FERGUSON TOWNSHIP PLANNING COMMISSION
Regular Meeting Agenda
Monday, June 13, 2022, 6:00 PM

SUBJECT: Farmstead View Subdivision Plan

SUBJECT: Farmstead View Preliminary Subdivision Plan 5th Review

TO: Kristina Bassett, Community Planner
FROM: Ron Seybert, Township Engineer
DATE: May 23, 2022
SUBJECT: Farmstead View Preliminary Subdivision Plan
Fifth Review (ES – 421)

GRADING PLAN

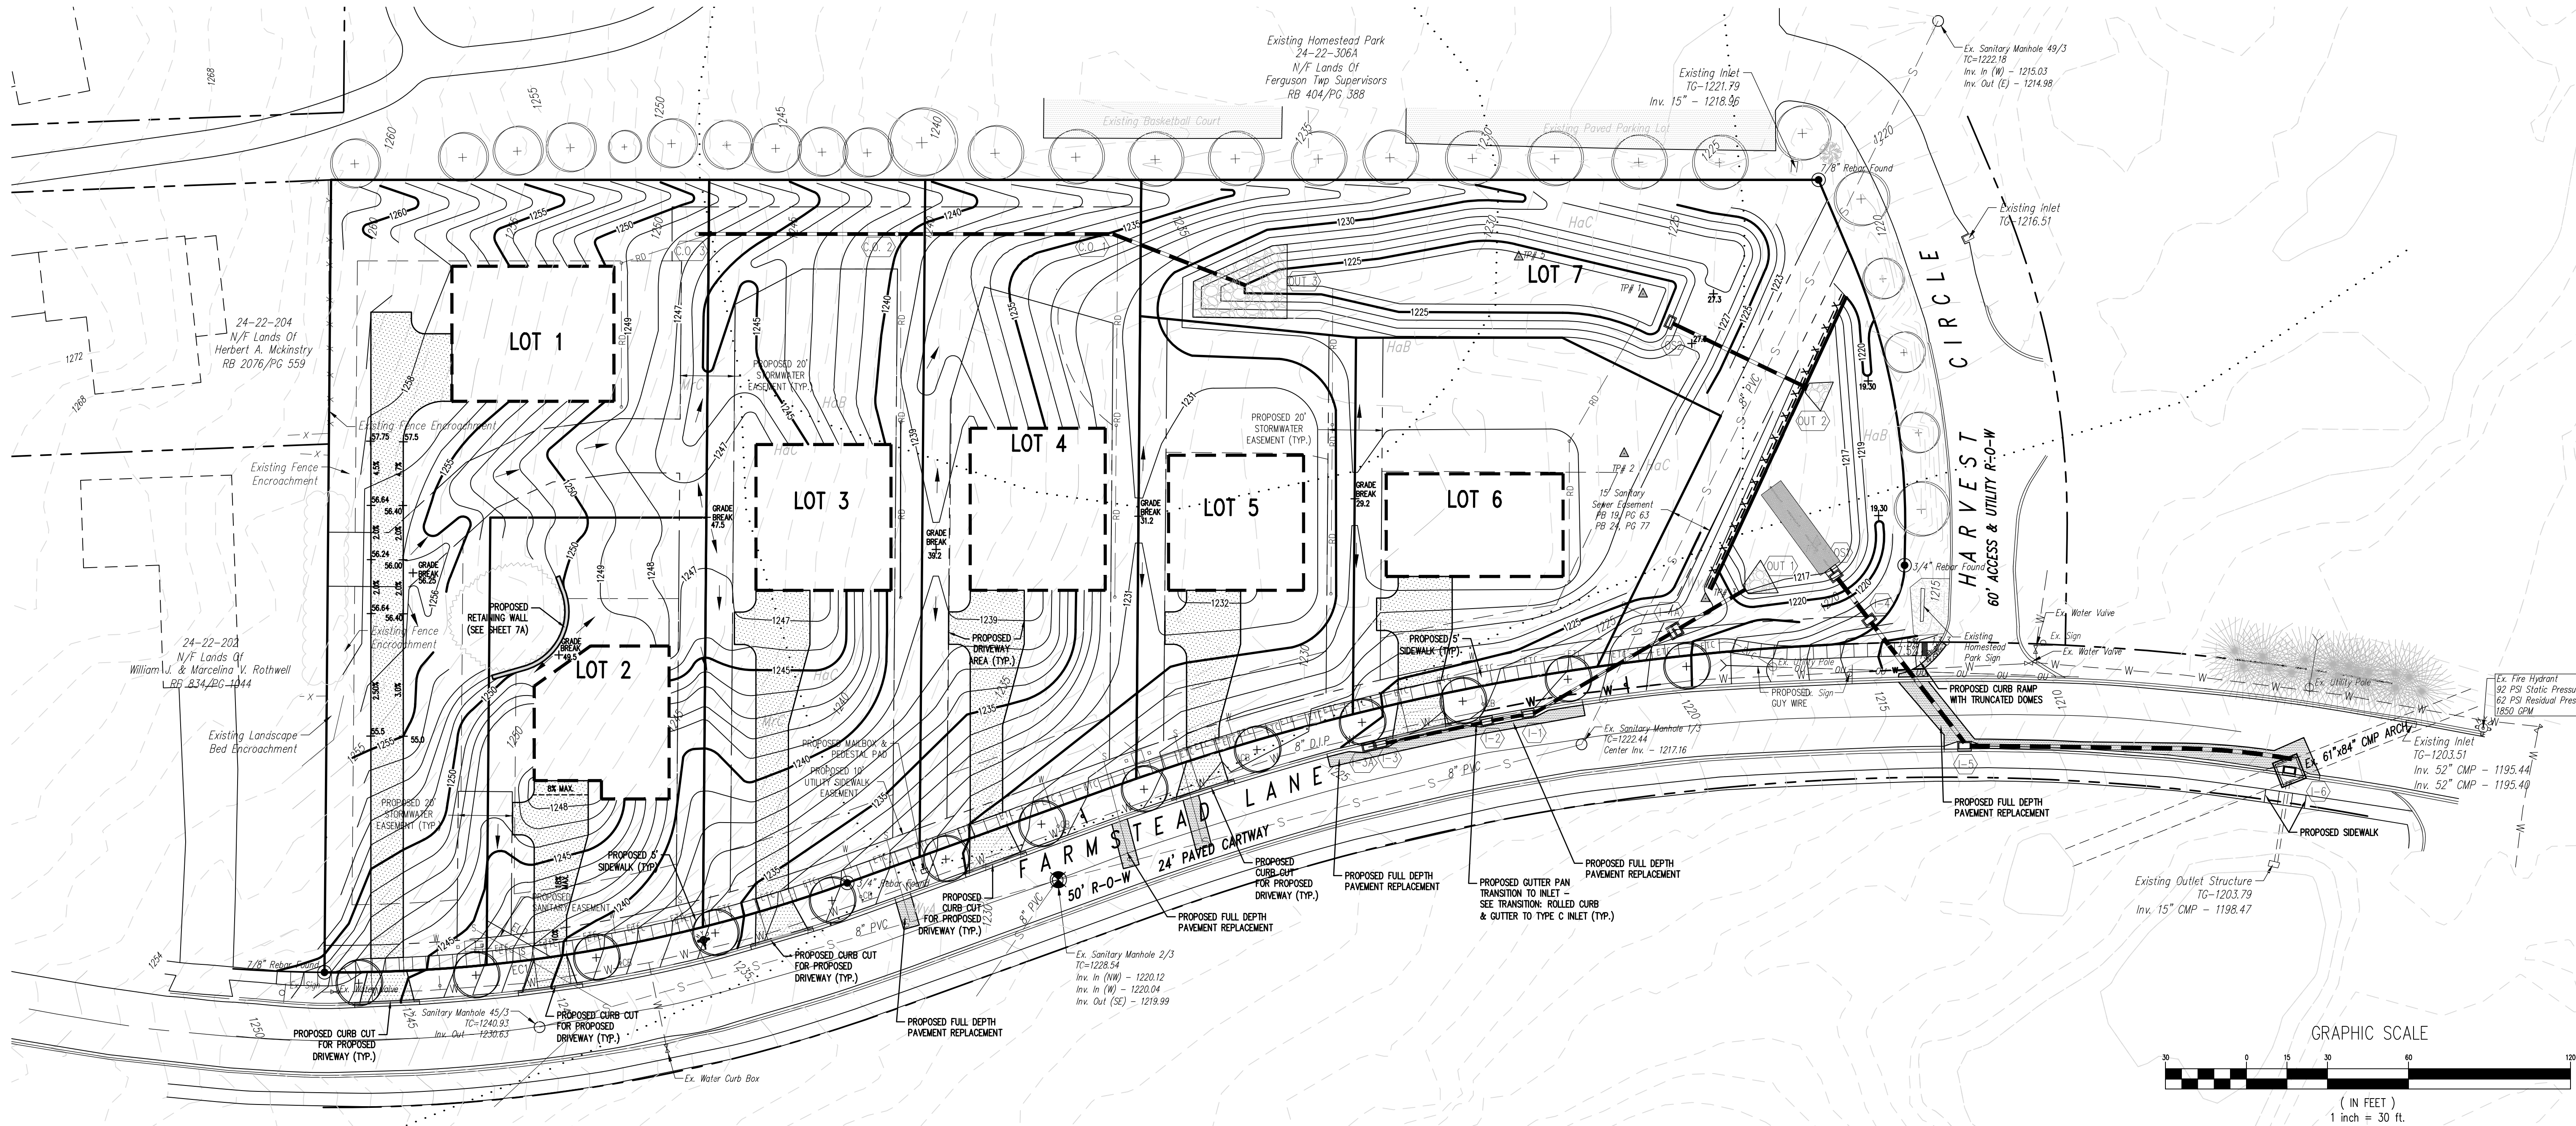
2022 04 26 Comment: Comment addressed; however, remove note 10 from the Preliminary Land Development Plan Grading Plan

2022 05 23 Comment: Comment addressed.
